ADDENDUM NO. 2

CITY OF PLYMOUTH

**CONTRACT DOCUMENTS FOR
KILMER PARK STREET RECONSTRUCTION PROJECT
CITY PROJECT NO. ST189001.001**

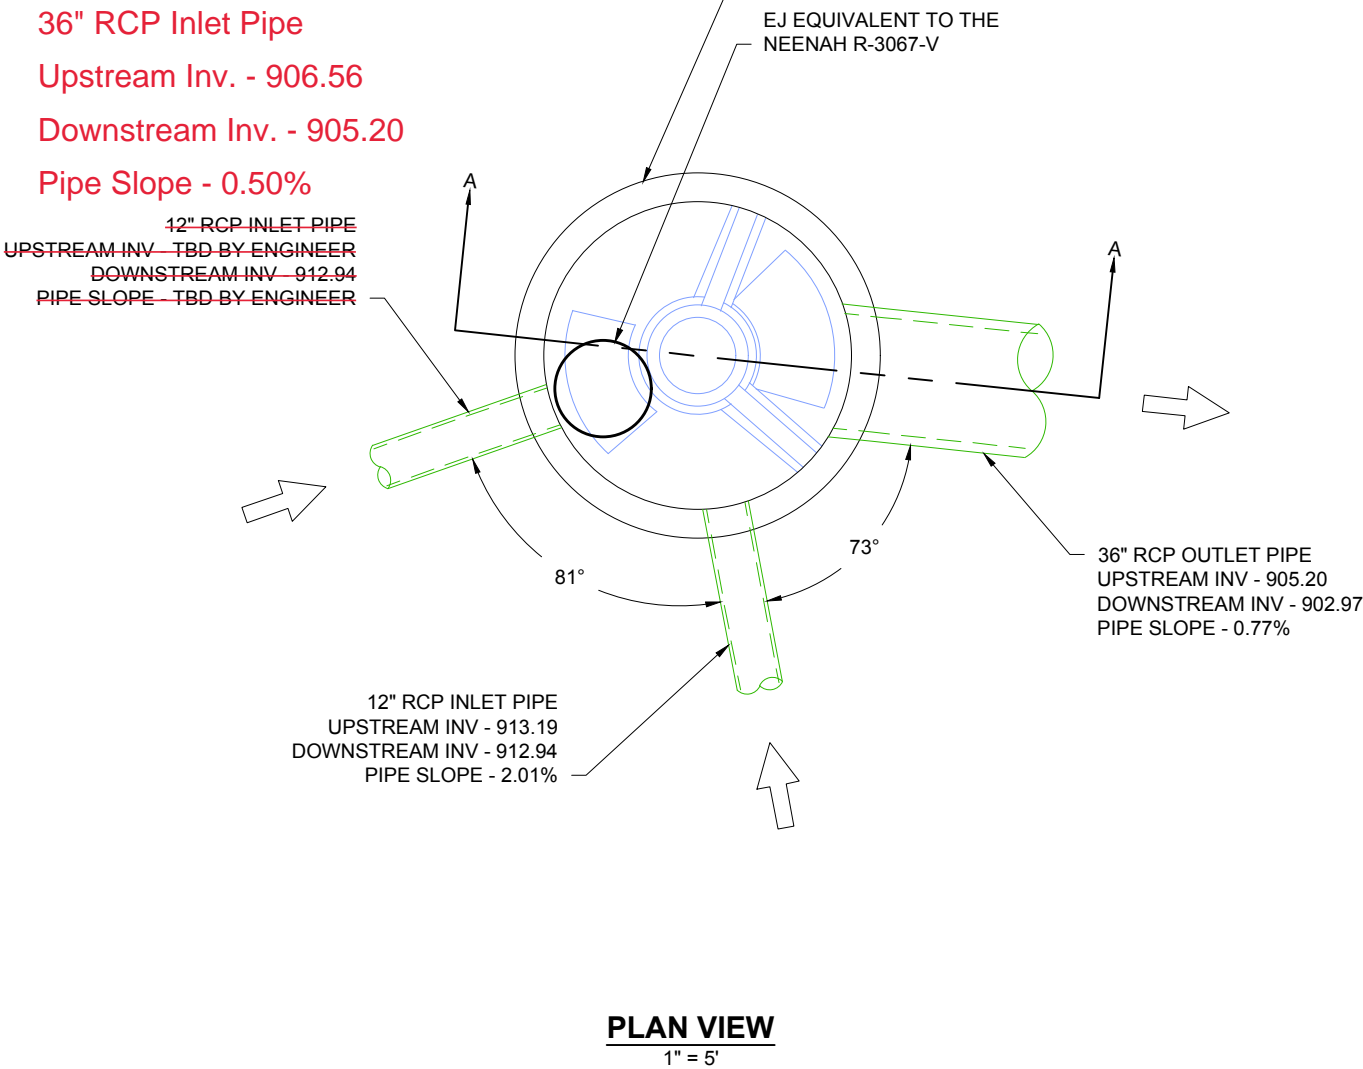
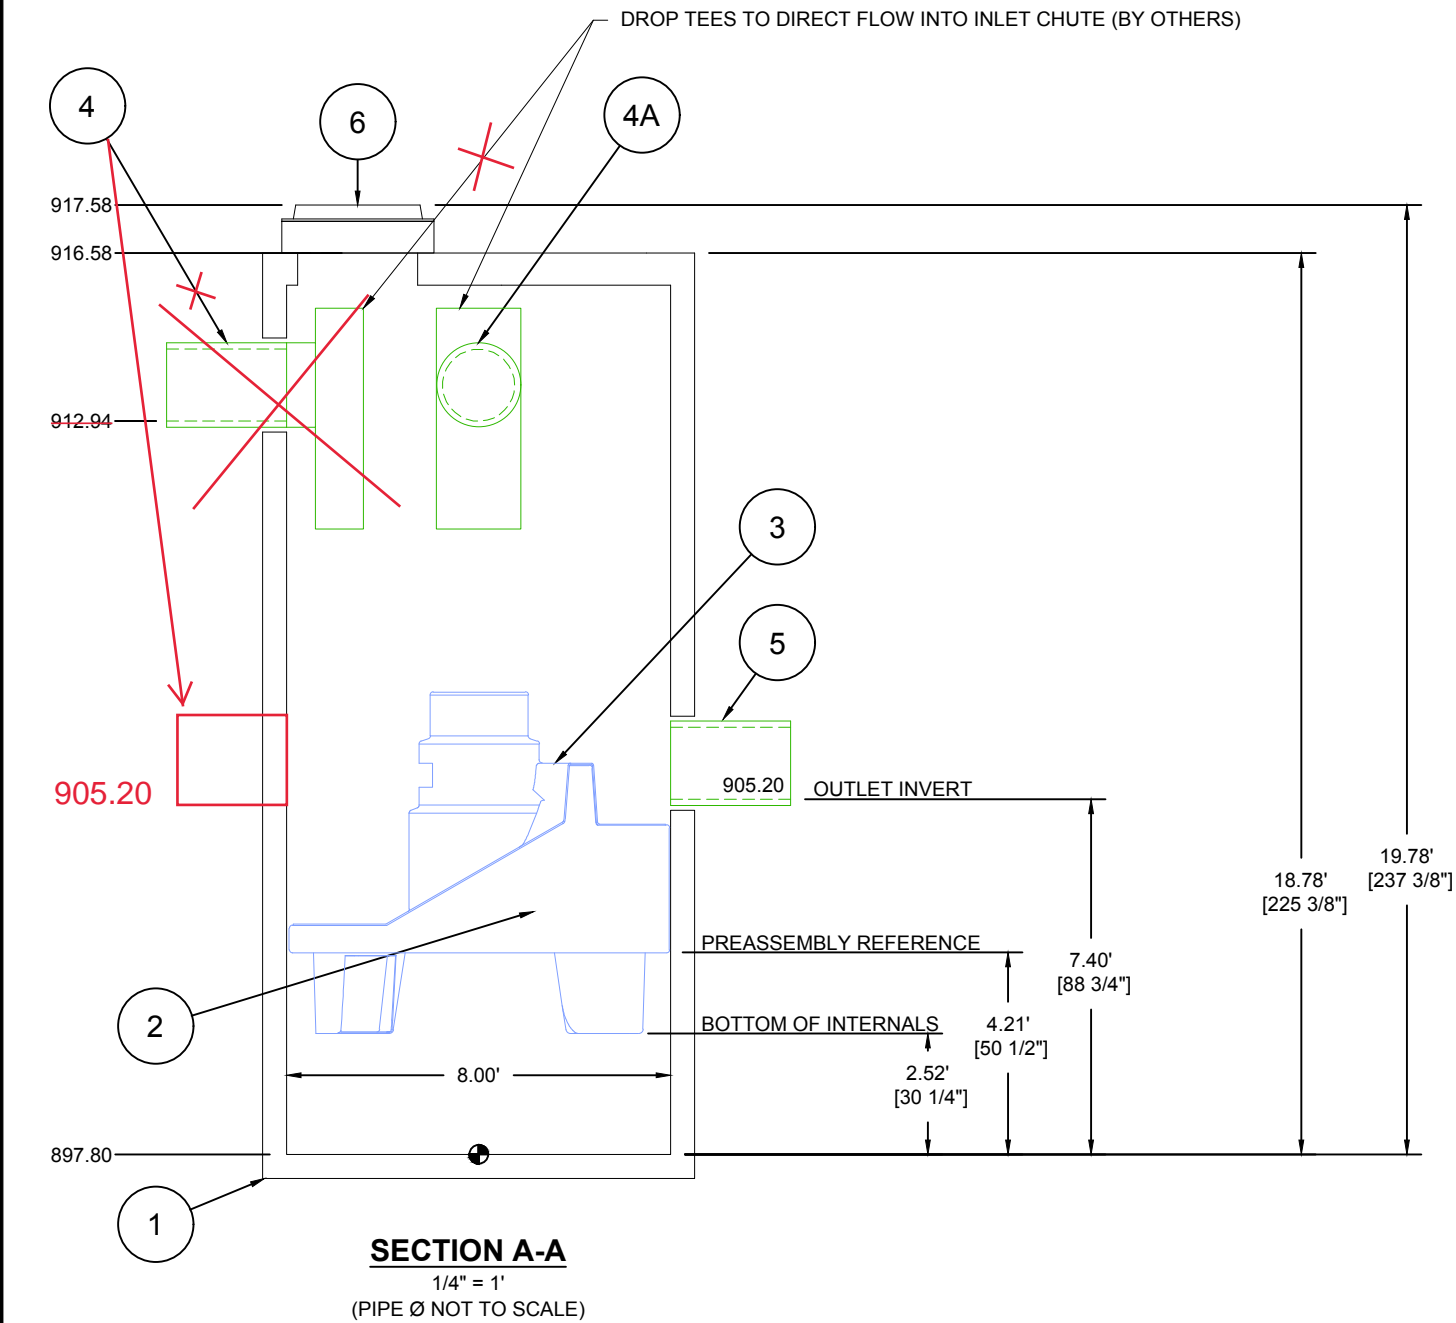
- 1) (02300.K.C.i) - The location of hydrodynamic separator manufactured by Contech for Site 2 was changed to CB 67 from STMH 66.
4. Appendix
 - a. The Contractor shall replace Appendix B – Hydrodynamic Separator (ADS) with "revised", attached. Revisions to structures at both site 1 and site 2 were made.

PARTS LIST : 8' FIRST DEFENSE HC			
ITEM	SIZE (IN)	MATERIAL	DESCRIPTION
1	96	-	I.D. PRECAST MANHOLE
2	-	-	LEDGER SUPPORT
3	-	-	SEPARATION MODULE
4	12 36	RCP	INLET PIPE (BY OTHERS)
4A	12	RCP	INLET PIPE (BY OTHERS)
5	36	RCP	OUTLET PIPE (BY OTHERS)
6	-	-	EJ W EQUIVALENT TO THE NEENAH R-3067-V

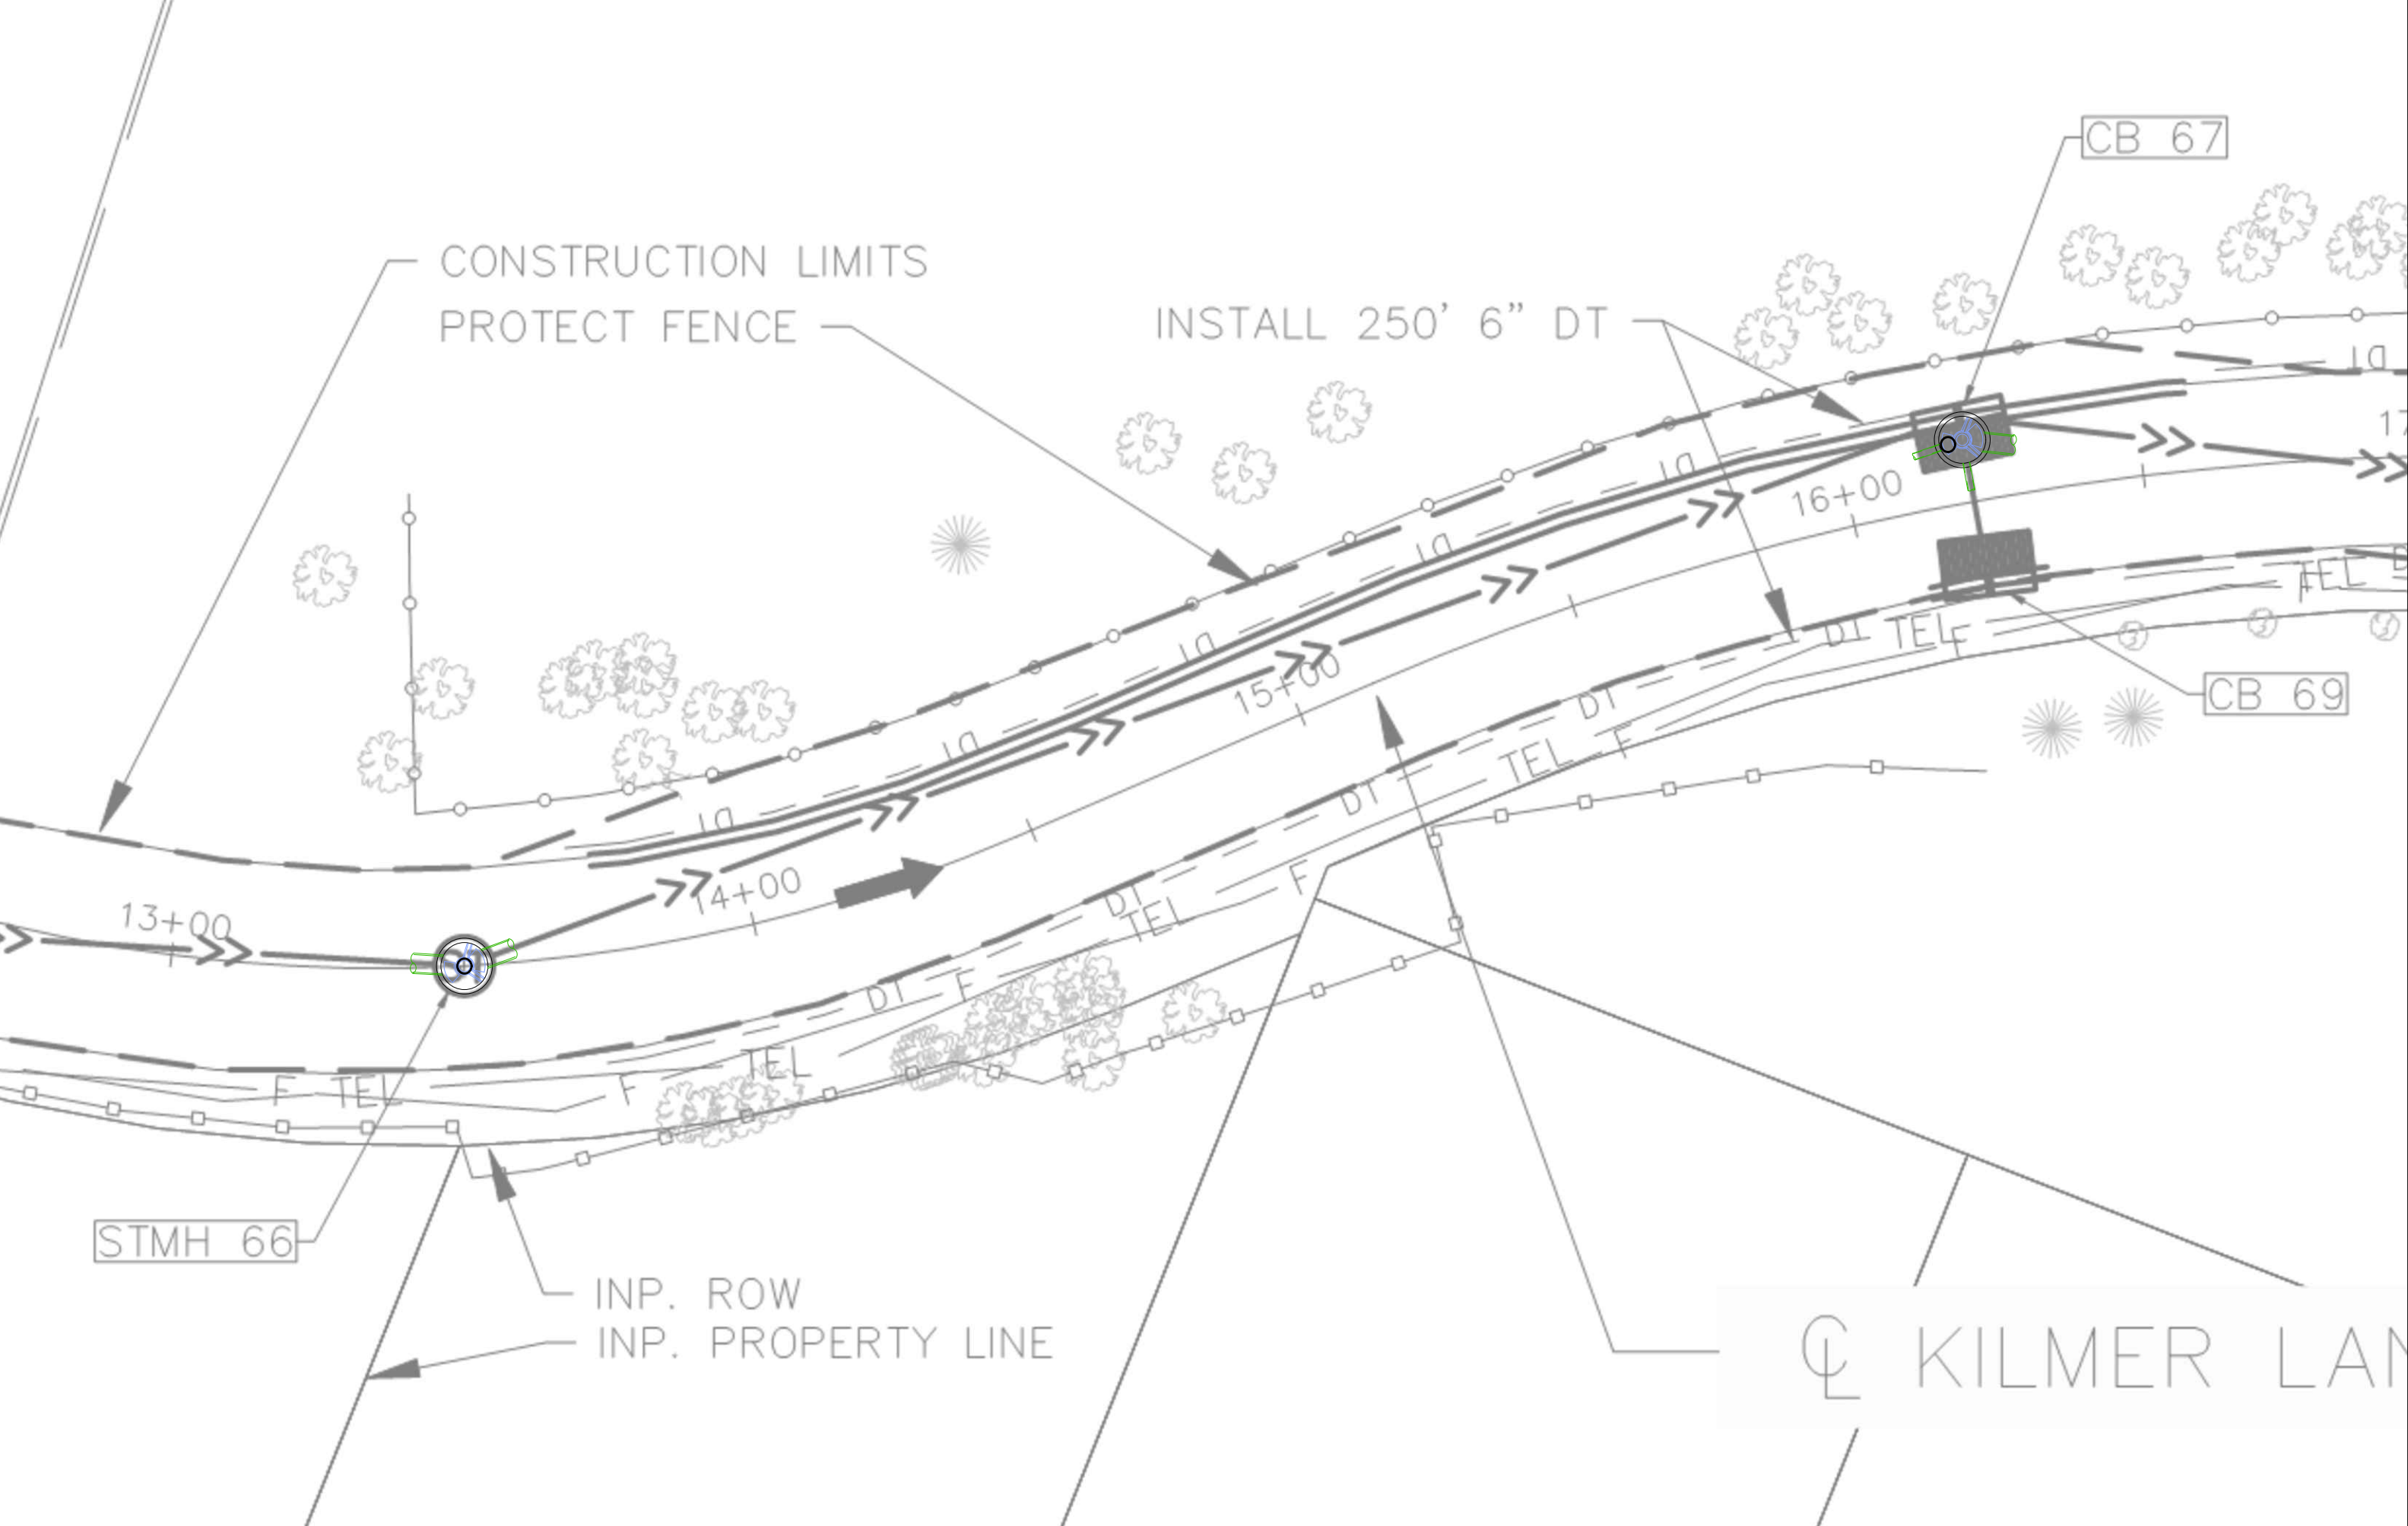
1. Plan Revision
 - a. The Contractor shall replace Sheet 51 with "revised", attached. The following items were revised:
 - 1) Note regarding location of hydrodynamic separate for site 2 revised to be STMH 66 and/or CB 67.

CB 67

STMH 66

Appendix C - Hydrodynamic Separator (Contech)

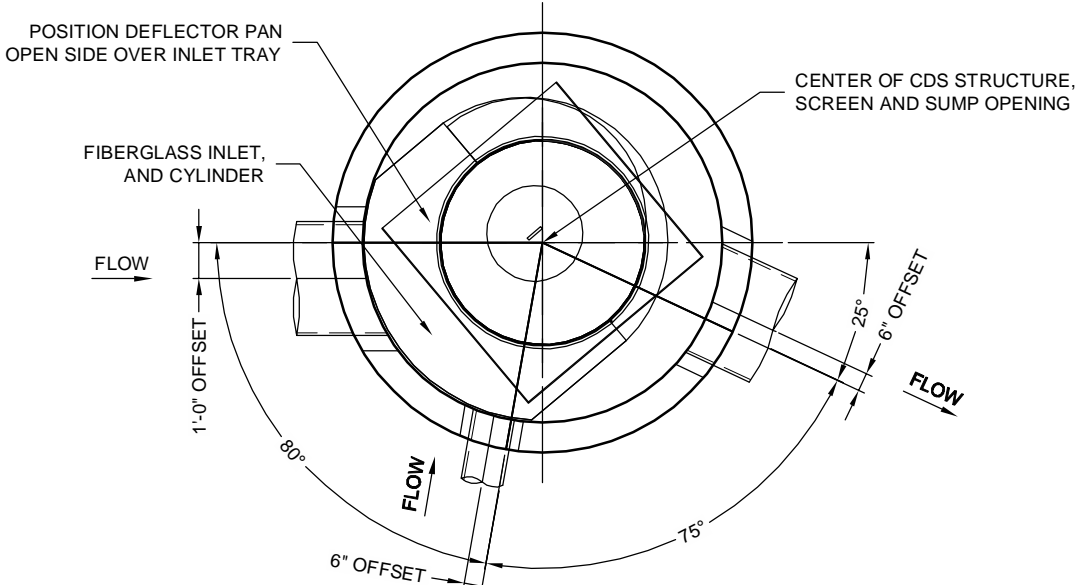
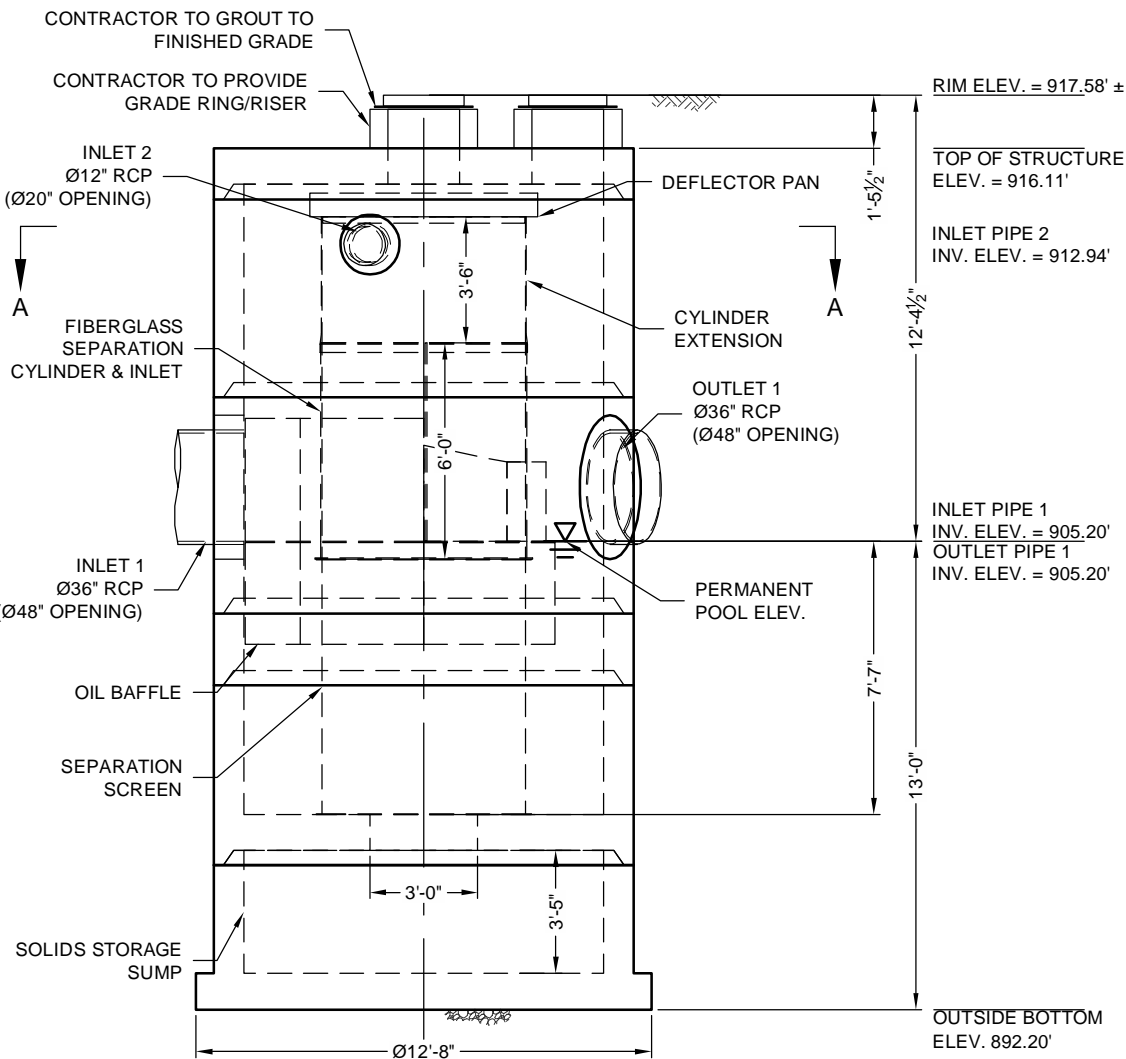
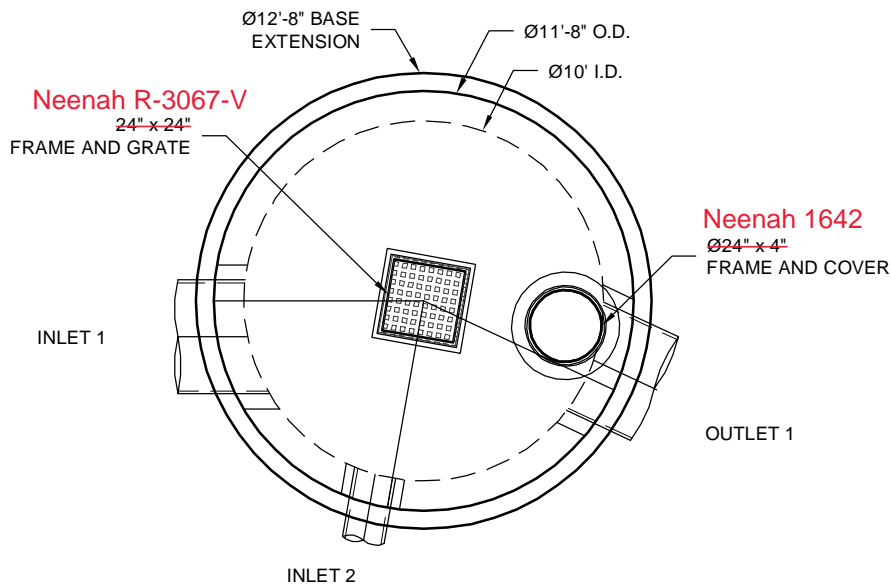
- b. The Contractor shall replace Appendix C – Hydrodynamic Separator (Contech) with "revised", attached. The structure type for site 2 was changed and moved from STMH 66 to CB 67.

CDS5668-10-C - 585878-20
KILMER PARK STREET
RECONSTRUCTION
MINNEAPOLIS, MN
for SYSTEM: CB67
